Staff Report

To: Salt Lake City Planning Commission
From: Daniel Echeverria, 801-535-7165, daniel.echeverria@slcgov.com
Date: May 19, 2016
Re: PLNPCM2016-00194, Central 9 Lofts Planned Development

Planned Development

PROPERTY ADDRESS: 863 S, 865 S, 873 S, & 877 S 200 West
PARCEL ID: 15-12-254-014, 15-12-254-042, 15-12-254-016, & 15-12-254-017
MASTER PLAN: Central Community
ZONING DISTRICT: FB-UN2, Form Based Urban Neighborhood-2

C2 200 WEST ELEVATION
 SCALE: 1/8"=1'-0"

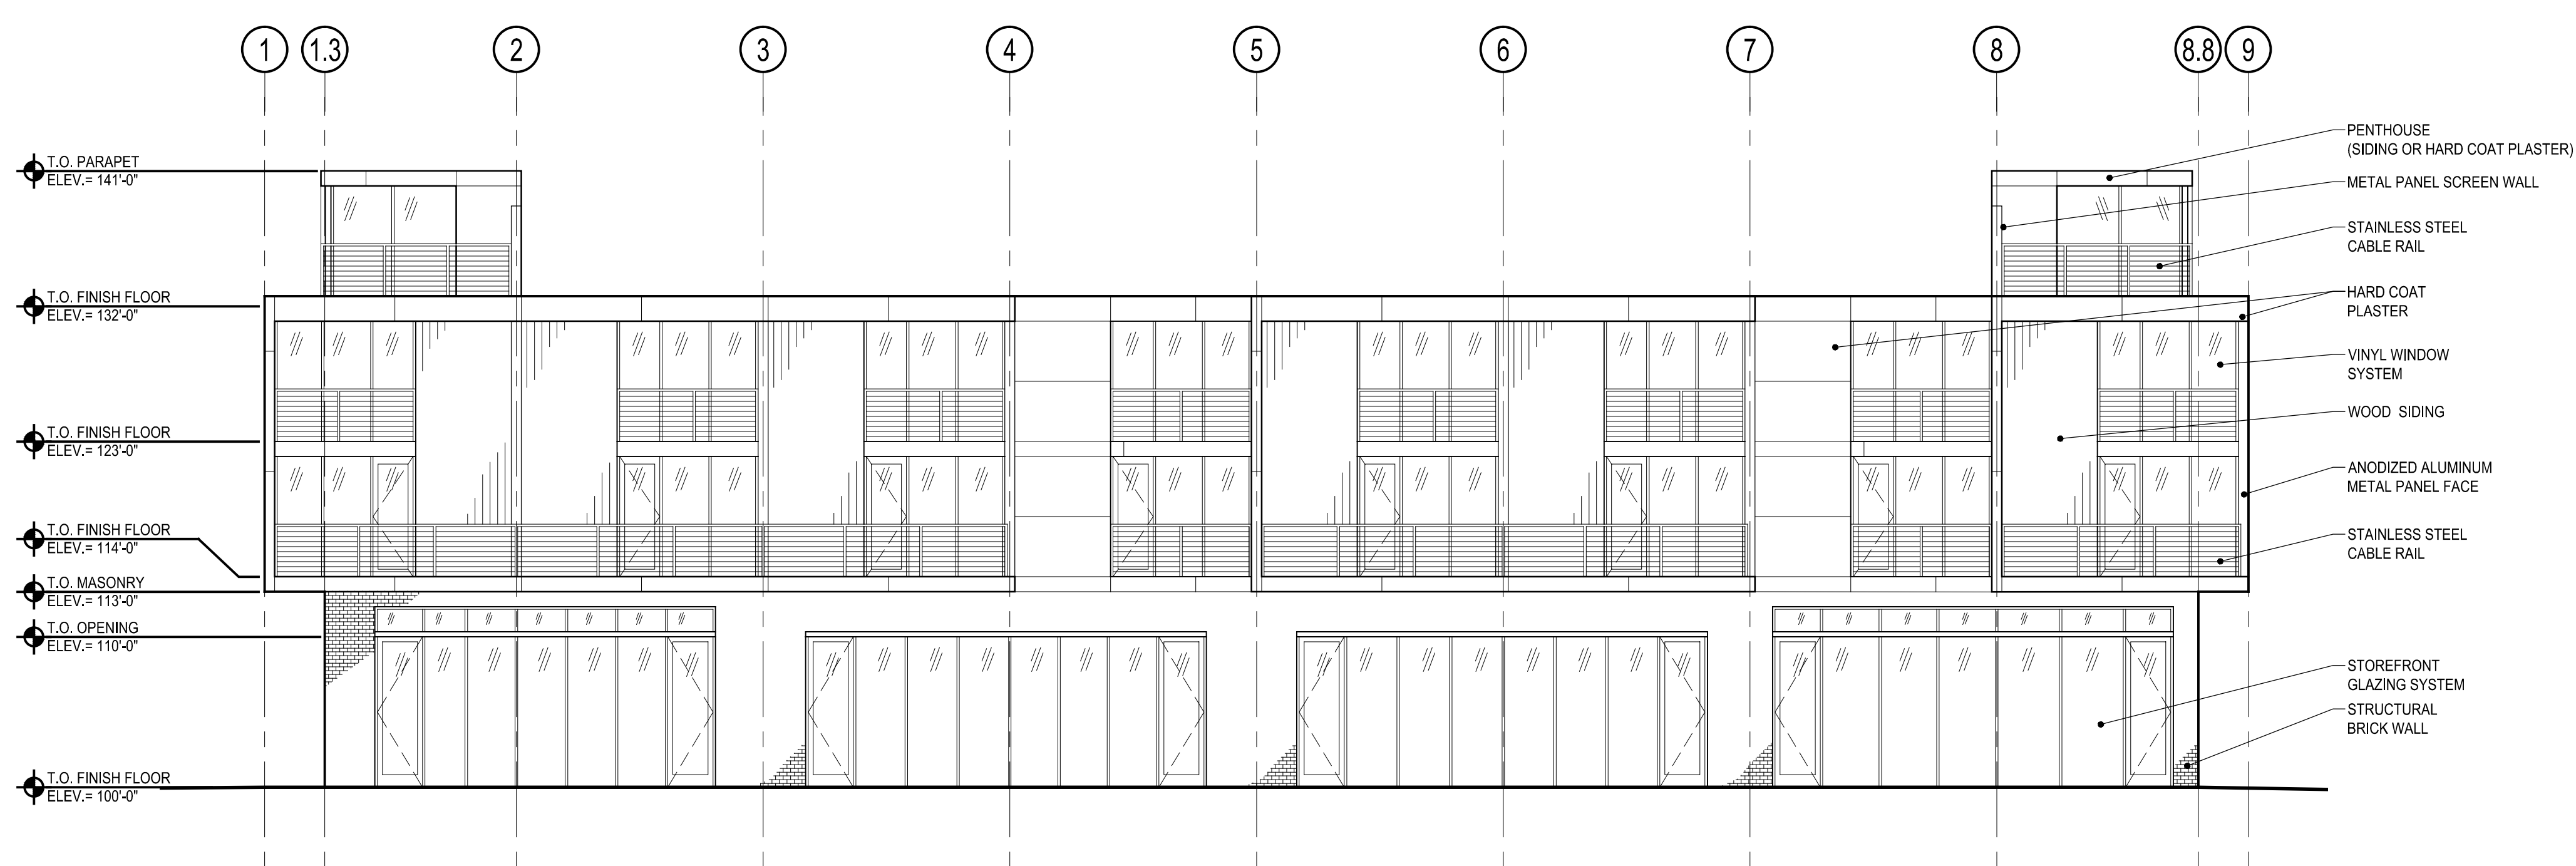
The above image is the west elevation that faces 200 West and the TRAX station. The proposed art wall can be seen on the right, as well as one of the proposed vertical building name signs on the right edge of the building. The other building name sign is on the east elevation and is in the same position.

The development is also requesting relief from the material restrictions of the zone in order to incorporate a large art wall. The ordinance requires that “A minimum of 70% of any street facing building facade shall be clad in glass, brick, masonry, textured or patterned concrete, wood, or stone. Other materials may count up to 30% of the street facing building façade.” On the west face of the building, approximately 15% of the façade will be covered by an art wall. This wall would otherwise be covered by one of the materials required by the zoning and reduces the amount of the façade covered by the required materials to 62%, which is 8% less than the 70% standard. However, public art generally benefits the community and could provide cultural character to this redeveloping intersection. The developer is proposing to commission a local artist to design the art piece and the proposed image shown on the elevations and renderings is a placeholder for the final art. Staff is recommending approval of the reduced required material minimum in order to incorporate the large public art wall.

C2 ALLEY (EAST) ELEVATION

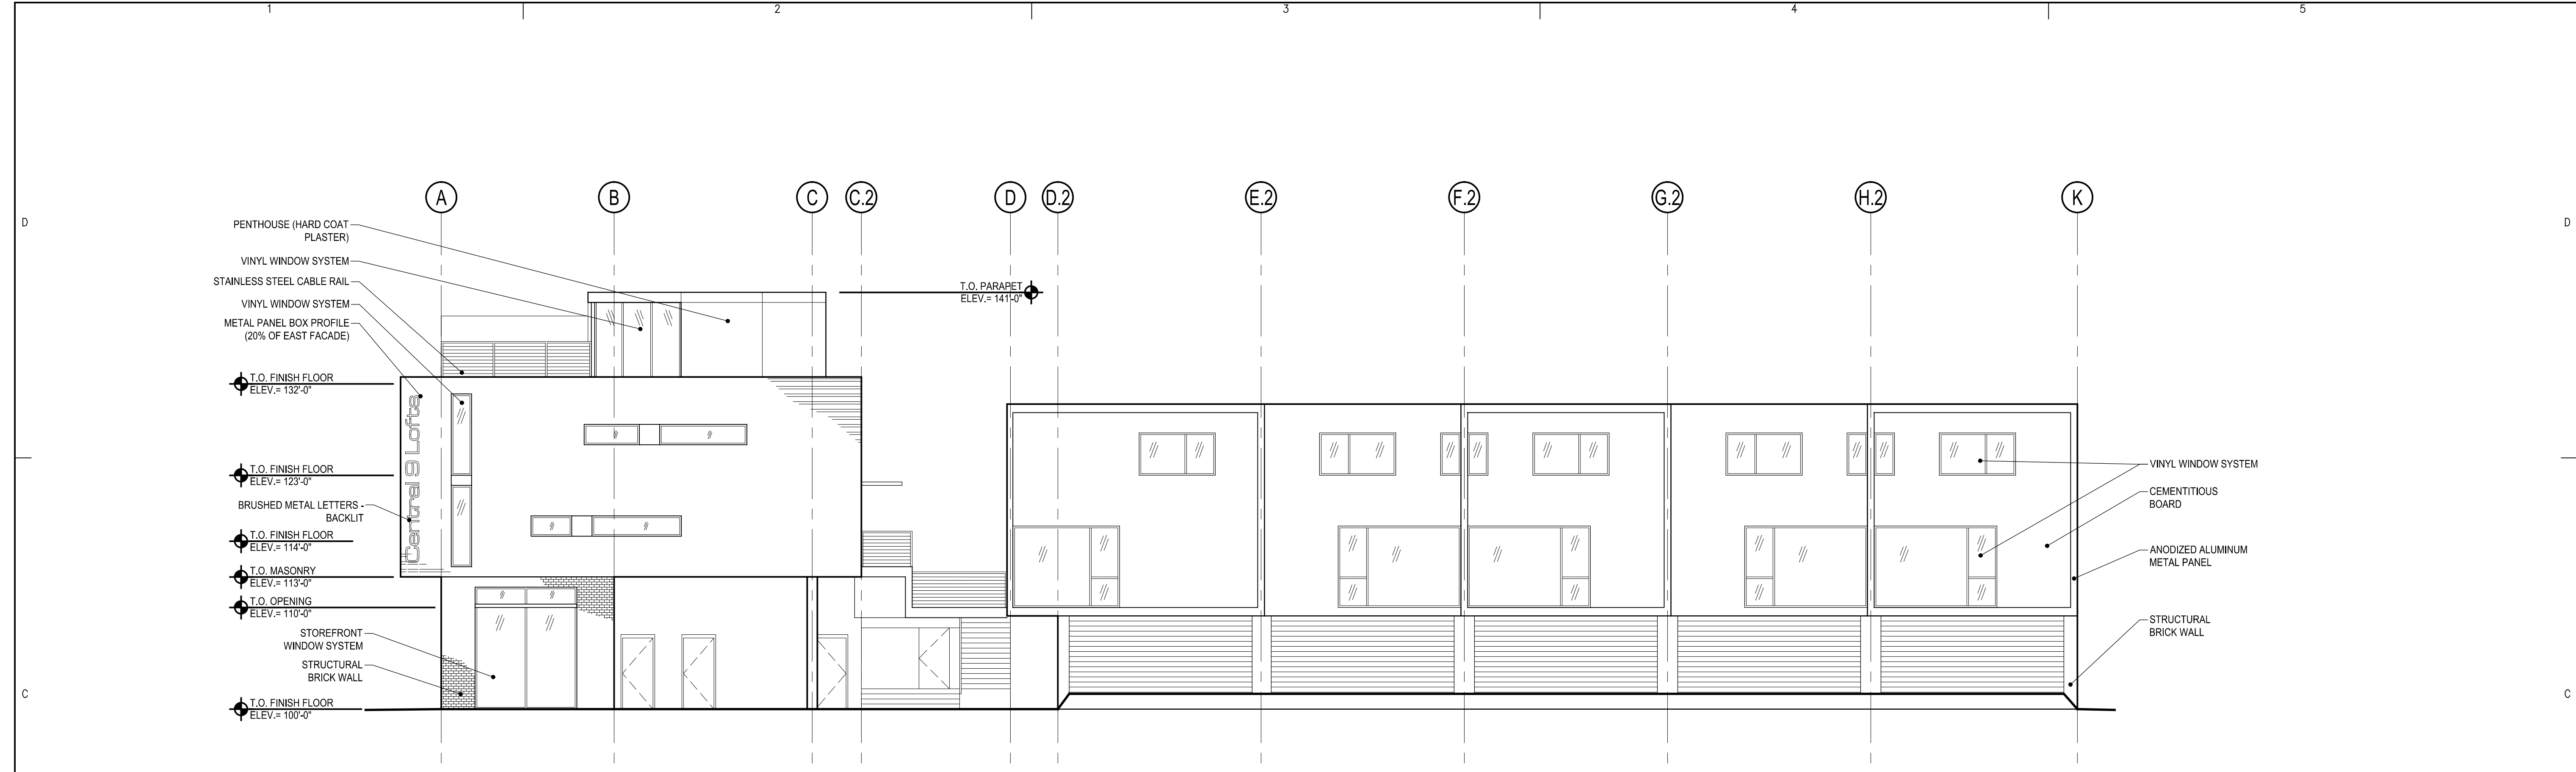
The developer is proposing to build residential units along the east side of the property, next to the alley. These units are proposed to have 2-car garages on the ground floor with garage doors that face the alley. With the proposed configuration, vehicles would normally back out of these garages into the alley. In a town-home (single-family attached) development, these garages would be allowed. However, in a multi-family development garages that take access from the alley are not allowed. As such, the developer is requesting to modify this restriction for this development.

The intent of the parking code restriction is to reduce the number of vehicles using the alley for parking and thus reduce the potential for collisions in an alley. Multi-family uses generally have more parking than a single-family use and thus an increased potential for collisions. Additionally, when the restriction was written most alleys were unimproved and unpaved. Unpaved, dirt alleys would generally not hold up well with a high level of vehicle use.

However, in this case, the alley is paved and does not have the same potential for vehicle use issues. Further, the proposed parking configuration functions the same as if the residential units were townhomes (single-family attached), and vehicle access from the alley would in fact be required for townhome development in this zone. The Transportation division also has determined that this is an acceptable configuration and would not pose any safety issues.

This is the east elevation that faces the alley. The five garages shown here are not normally allowed by the zoning regulations for multi-family uses as they require backing into the alley to get out.
